# CITY OF ALBUQUERQUE

**Re: Shops @ the 24s  
32424 Louisiana Blvd NE  
Grading and Drainage Plan  
Engineer's Stamp dated: 8/14/2018 (H19D001)**

## DRAINAGE AND TRANSPORTATION INFORMATION SHEET (REV 6/2018)

# **The Shops @ the 24's Drainage Analysis Report**

#### GRADING & DRAINAGE PLAN

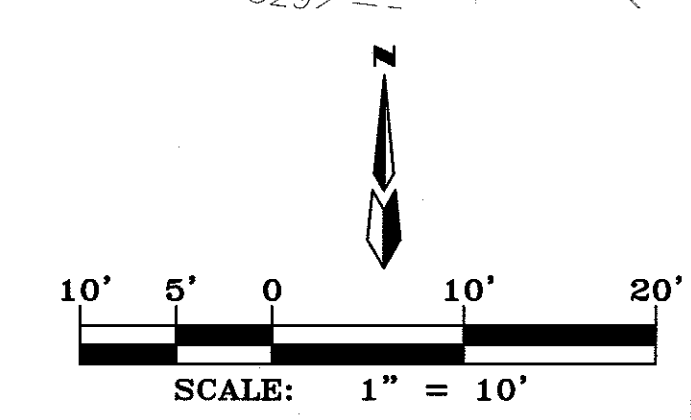
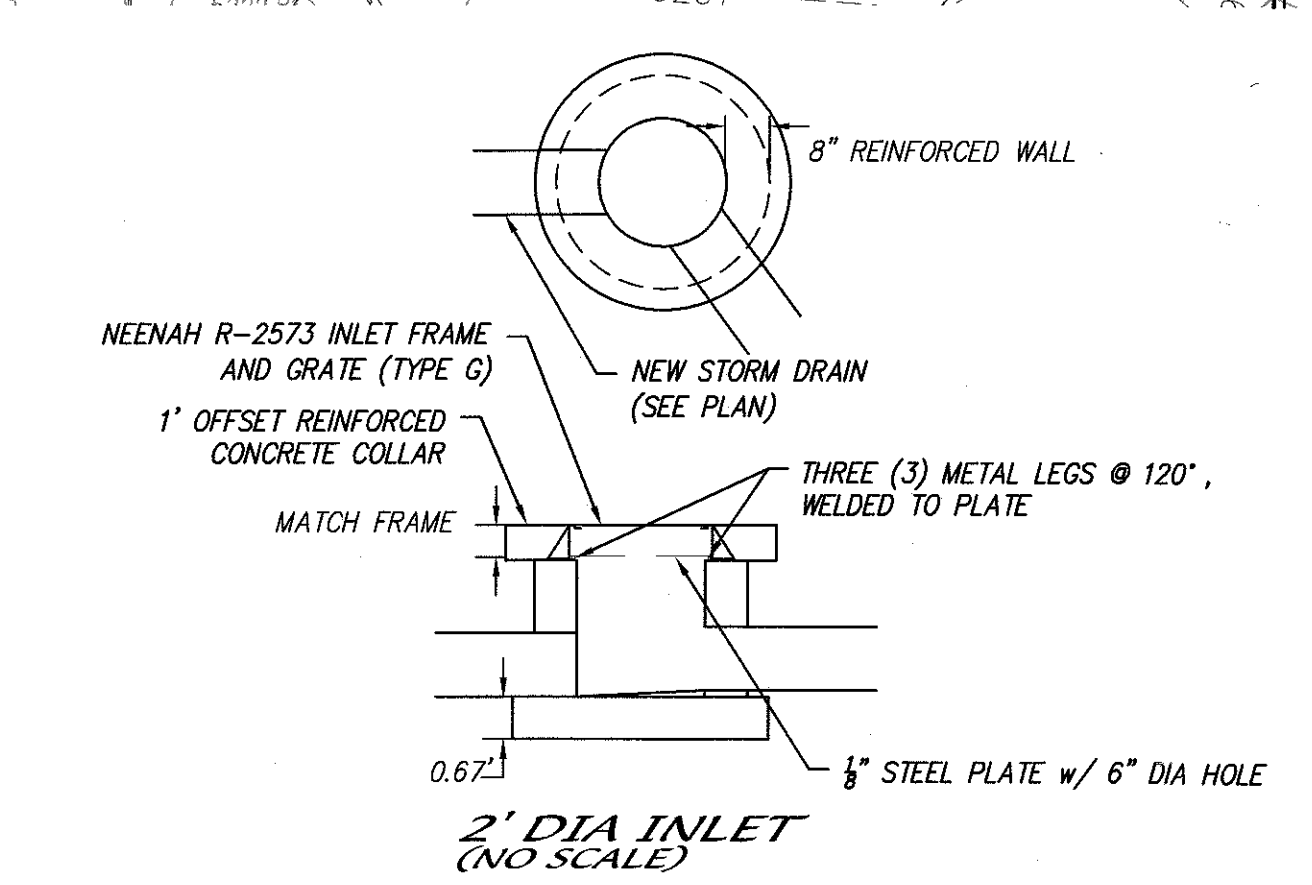
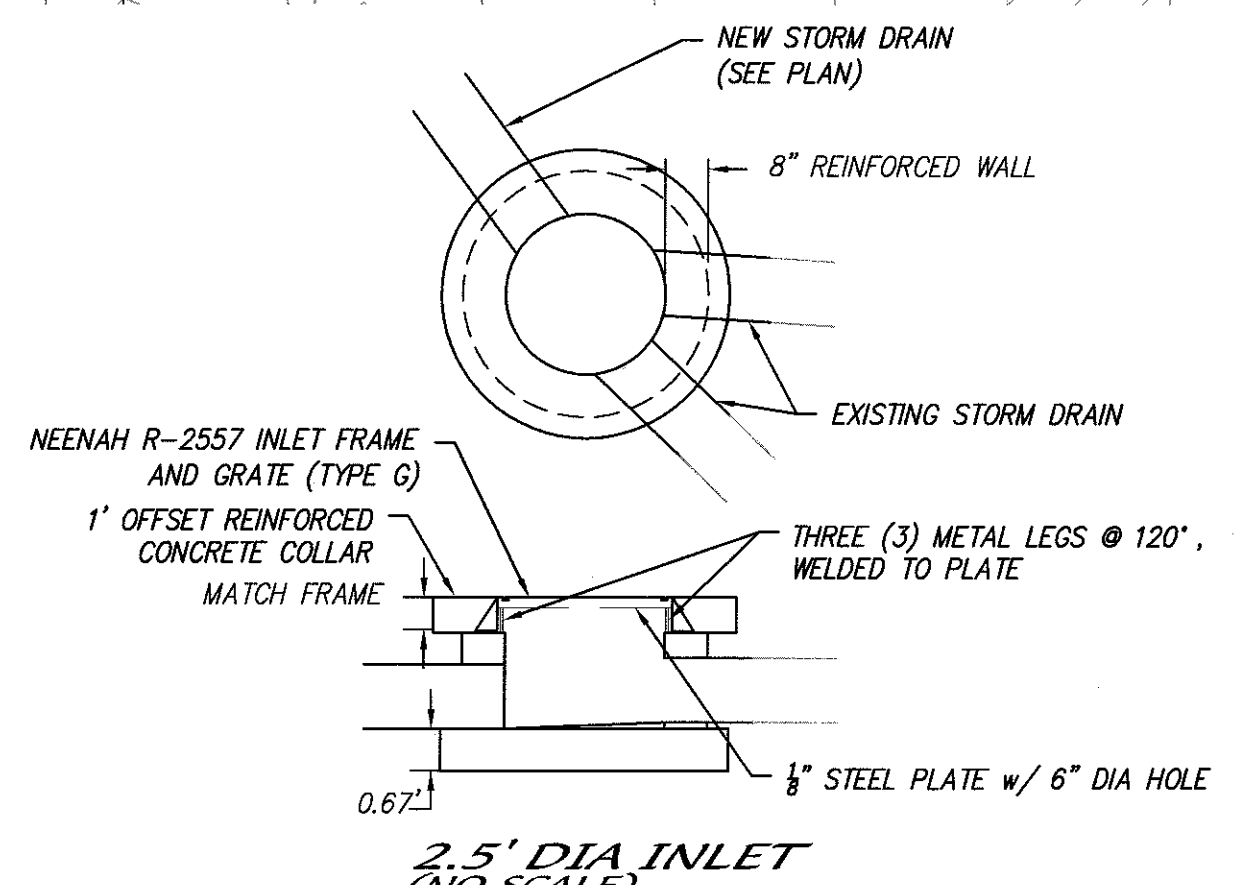
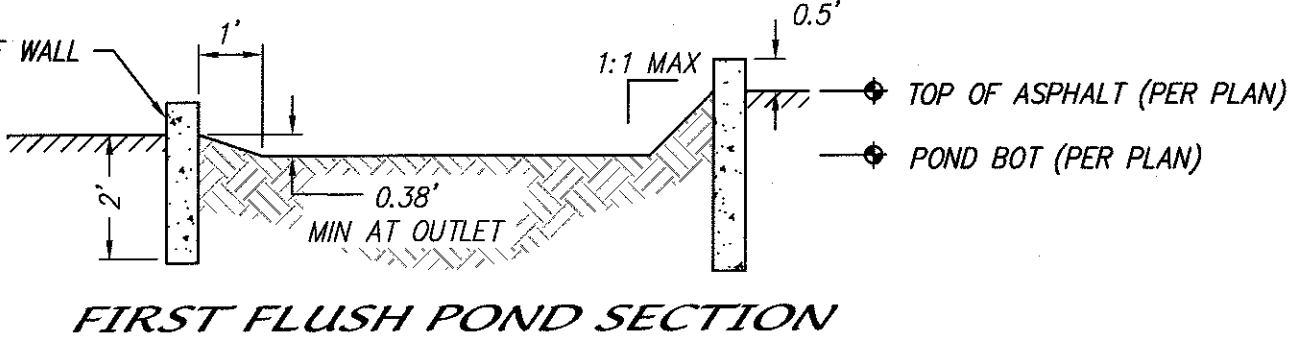
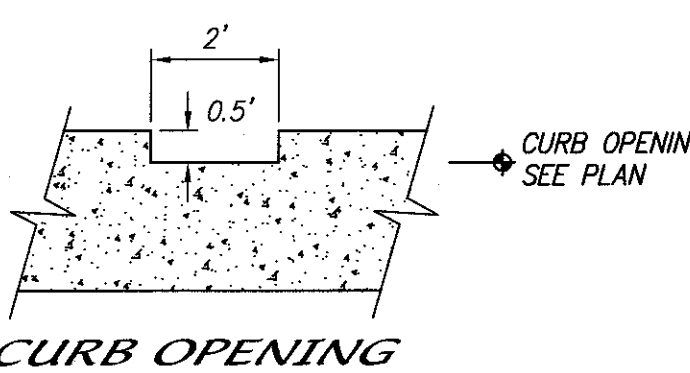
1. Add a general statement of the Drainage History to the G&D Plan. The history should mention that this 3.05 acre site was approved in about 1978 for one building with runoff detained on the roof, and asphalt parking lots on the west, south, and east sides of the building also used to detain runoff. Recently the parking lot on the east side of the existing building was converted into an underground parking lot and the detention there was replaced by retention. Two existing parking lot ponds on the south side of the existing building drain to sump inlets with 6" diameter orifice plates located 2" below the surface of the grates. The three existing parking lot ponds on the west side of the building have fallen into a state of disrepair the east inlet orifice plate has become loose inside the inlet, the middle inlet has been modified and the orifice plate is missing, and the west inlet orifice plate rusted through. The three inlets on the west side of the building are of a different type than the two on the south but they seem to have about the same capacity.

2. The Drainage Management Plan should say that this project will repair/replace the ponds on the west side of the existing building so that the detained volume will be equal to or greater than that originally planned and the runoff rate will be equal to or less than that originally planned. The Management Plan and History should show up on both the G&D Plan and on the Maintenance Covenant.

4. The contours and spot elevations do not agree, for example the existing 5292 contour goes thru the existing 5222.91 spot elevation. The topography must be fixed before an estimate of the parking lot detention volume can be made. The new detention volume should be equal to or greater than the originally designed volume and there should not be any bypass flows from areas that previously flowed to detention ponds, so the new building must drain to a detention pond.

5. Additionally each first flush pond must be designed for the required volume of the area draining to it. The area draining to each first flush pond must be identified on the basin map. Calculations of the required volume and the provided volume must be presented on the plan and on the exhibits to be recorded with the maintenance covenant (multiple pages may be needed for clarity).

6. The hydraulic calculations of the drainage structures are incomplete. The capacity of the inlets & orifice plates must be checked using both the orifice equation and the weir equation and the more limiting of the two should be used. The overflow spillway of each pond must be identified on a cross section detail on the plans and the 100 year elevation determined by the weir equation. The first flush elevation and 100 year elevation of each pond must be shown on the plan and on the exhibits to be recorded with the maintenance covenant.

7. The grading plan is still difficult to read. It is cluttered with unnecessary lines such as the outline of the tree drip lines. Please delete unnecessary lines and hatch patterns. Consider adding a separate demolition plan to show all of the existing improvements, trees, signs, light poles, curbs, asphalt, inlets, and storm drains be removed, or include removal notes on the Grading Plan.

8. Please add the line type that looks like a wall to the legend and add more spot elevations along the west side of the new building. Show the wall or whatever it is in a typical section showing existing and proposed grades and dimensions on the west from the curb on Louisiana to the building including the wall. The line type appears on the west side of the building and around two planters on the east side of the building. The spots next the patio in the northwest corner of the building indicate a 2' plus retaining wall but the limits of the wall are not clear.

9. A valley gutter is recommended in the swale on the east side of the new building to get drainage from the south side of the new parking lot to the inlet. The swale must be shown with flow arrows and as a grade hinge line if not shown as a valley gutter. Similarly show the flow path from the northwest corner of the site to the inlet. An additional inlet may be needed to drain the northwest corner which currently drains to the inlet under the building.

10. Provide a detail showing finished contours in the proposed parking lot pond at the same elevations that are used in the AHYMO pond routing input file up to elevation 5223.0

11. Show contours inside pond #2 and provide volume calculations separate from pond #1. Is the line inside the pond supposed to be indicating a flat bottom at elevation 5222.37? If so, the line is not clearly identified as such and it is too close to the curb, particularly at the south end where the TC is 20" above the pond invert. Similarly show the contour at the first flush elevation 5222.75. Show additional finished contours at 5223.0 and 5223.5 in the parking lot around the pond. Show a section through the edge of pond 2 with dimensions. Add a section through the overflow spillway for pond 2 with weir calculation to determine 100 year elevation, unless it is a retention pond that spreads out into the parking lot. Provide a separate basin on the basin map for pond 2. If pond 2 is a retention pond, the 10 year volume should be contained in the pond and the limits of the 100 year 6 hour storm should be shown on the plan.

12. Clearly identify the area draining into first flush ponds 1, 3, & 4. What portion of the roof drains into each? Show contours and sections thru the edge of each pond and a section thru the spillway of each pond with weir calculations of 100 year elevation on the G&D Plan. Label both the 100 year and first flush elevation of each pond on the G&D Plan and on the Maintenance Covenant.
